EES Gymnasium Roof Replacement Building Committee
Eastford Elementary School
Thursday
August 2, 2018
Minutes

August 8, 2018
Eastford Elementary School Roof Replacement

Re: Proposed Substitution - Roof Railing

CORE THROUGH EXISTING CMU WALL FOR ROOF OVERFLOW DRAINAGE PIPE INSTALLATION

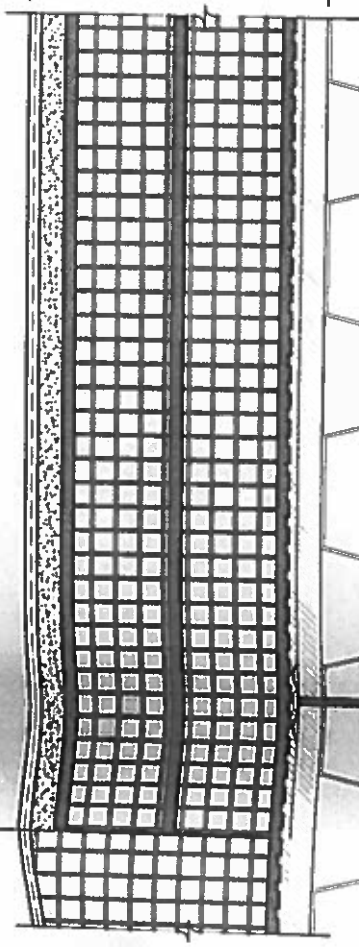
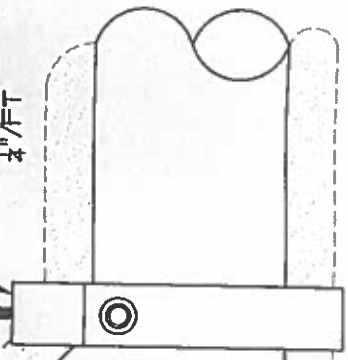
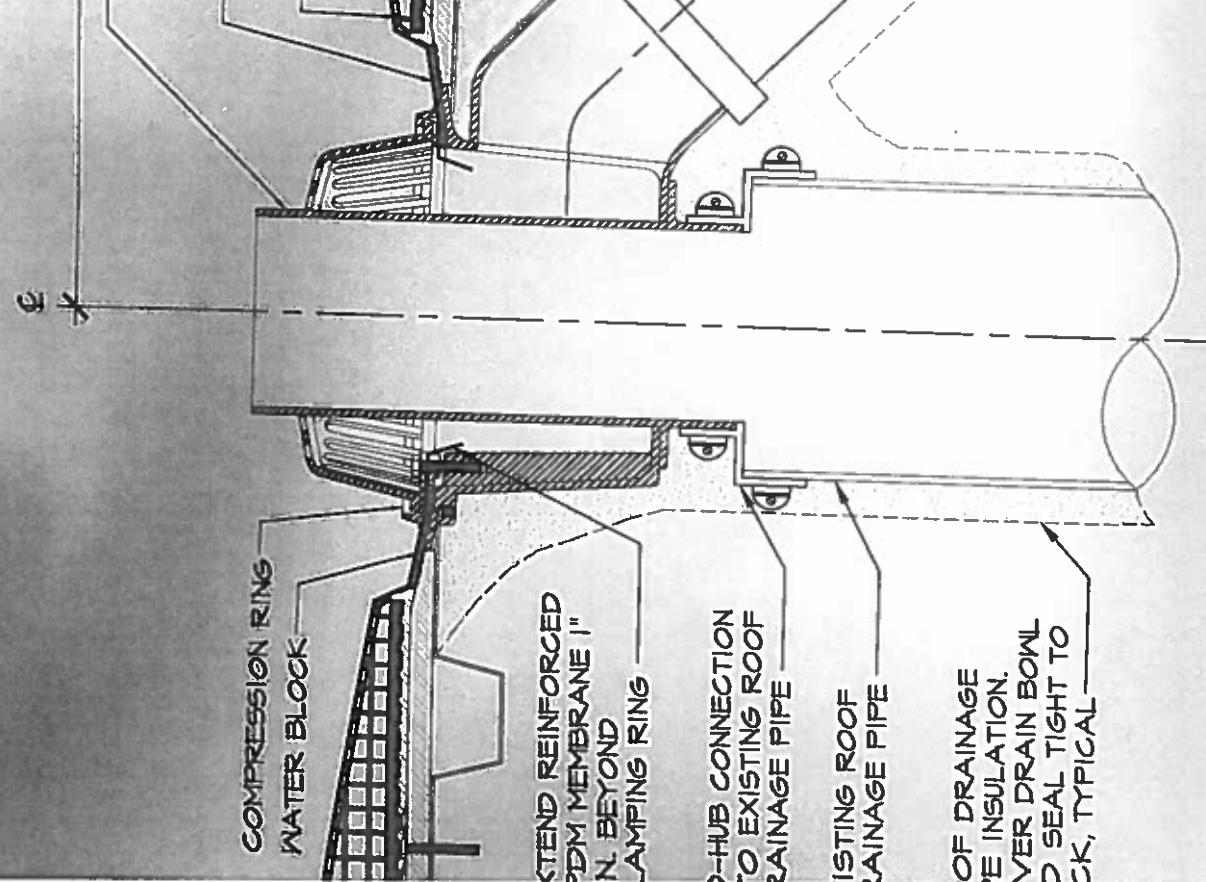
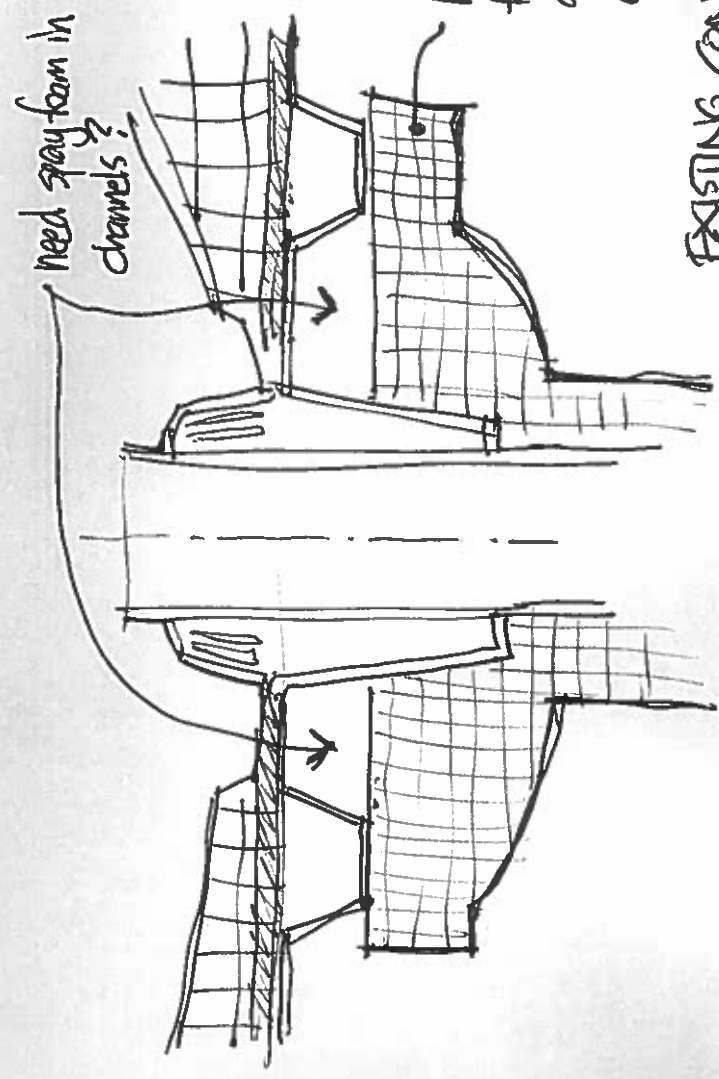
need stay form in channels?

18" rand disk with flat upper surface, but not apparently sealed at roof deck configurations?

EXISTING CONDITION OBSERVED BY COMMITTEE ON 9/2/12

The final plans had been appropriately modified to address the insulation concern brought up upon reviewing an earlier draft. Your comments on Thursday didn't seem to indicate that the contractor was held accountable for sticking with the plan.

Attached is the last page of your plans with comments and a drawing from the committee as well as a photograph of the area of concern.

Thank you for sending the photo of the potential area of concern. In reviewing the photo you sent, the roof drainage pipe is insulated and the drain bowl is insulated to the underside of the deck. That is the standard detail for a roof drain installation. When the roofing contractor schedules the warranty and punch list visit, we can have them stuff mineral batt insulation in between the flutes of the metal decking at the roof drain locations.

I've attached a photo of when the roofing contractor and the plumber were roughing in the roof drain assembly. In the photo you can see that insulation is installed beneath and around the roof drain. There could have been some misinterpretation during the call when we were discussing insulation at the roof drains. I will be reaching out to the roofing contractor to get a status update this morning. In meantime, please feel free to email or call if you have any questions or concerns.
